Access Compliance Report

Public Rights-of-Way

(Curb Ramps)

Intersection ID: 3246	Main Street: OLD_TIMBER_RD	Cross Street: SADDLE_PACE_LN	Location: S
ADA ID: 8E7F74490C46	Ramp Type: Perpendicular	Initial Pass/Fail: Fail	Overall Compliance: No
Severity Score: 21.25			
Codes/Mitigation Info/Possible Solution		Field Measurements/Component Compliance

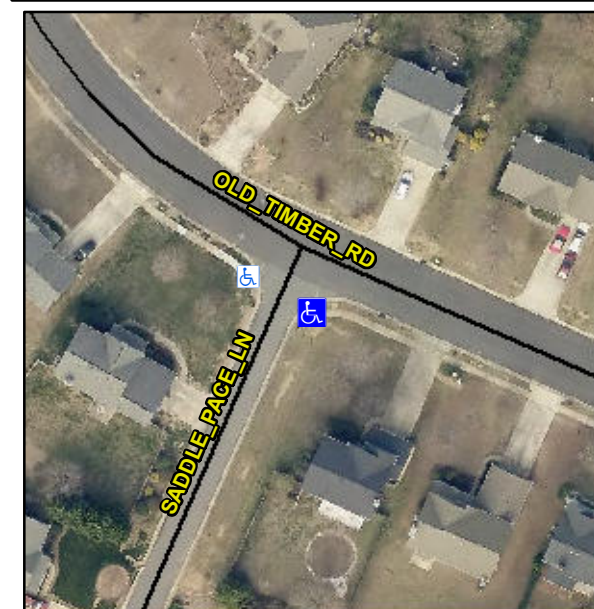
Not Found, R304.5.1, R304.5.3

Compliance	Description	Data	Compliance	Description	Data
N/A	Ramp Length (in)	49.0	Yes	Ramp Slope (%)	6.1
No	Ramp Width (in)	38.0	No	Ramp XSlope (%)	5.7
N/A	Flare Type LT	N/A	N/A	Flare Type RT	N/A
N/A	Flare Slope LT (%)	N/A	N/A	Flare Slope RT (%)	N/A
N/A	Flare Traversable LT?	N/A	N/A	Flare Traversable RT?	N/A
N/A	Landing Length (in)	N/A	N/A	DWS Provided?	N/A
N/A	Landing Width (in)	N/A	N/A	DWS Contrast?	N/A
N/A	Landing Slope (%)	N/A	N/A	DWS Length (in)	N/A
N/A	Landing X Slope (%)	N/A	N/A	DWS Full Width?	N/A
N/A	Landing Curb? (Y/N)	N/A	N/A	DWS Offset (in)	N/A
N/A	Shared Landing?	N/A			
N/A	Gutter Ponding?	N/A	N/A	Gutter Slope (%)	N/A
N/A	Gutter Lip Ht (in)	N/A	N/A	Gutter X Slope (%)	N/A
N/A	Painted X Walk1?	No	N/A	Painted X Walk2?	N/A
	X Walk 1 Direction	To NW		X Walk 2 Direction	N/A
N/A	X Walk 1 Width (in)	N/A	N/A	X Walk 2 Width (in)	N/A
	X Walk 1 Slope (%)	4.2		X Walk 2 Slope (%)	N/A
	X Walk 1 X Slope (%)	2.9		X Walk 2 X Slope (%)	N/A

Possible Solutions:

Remove & Replace Entire Ramp.
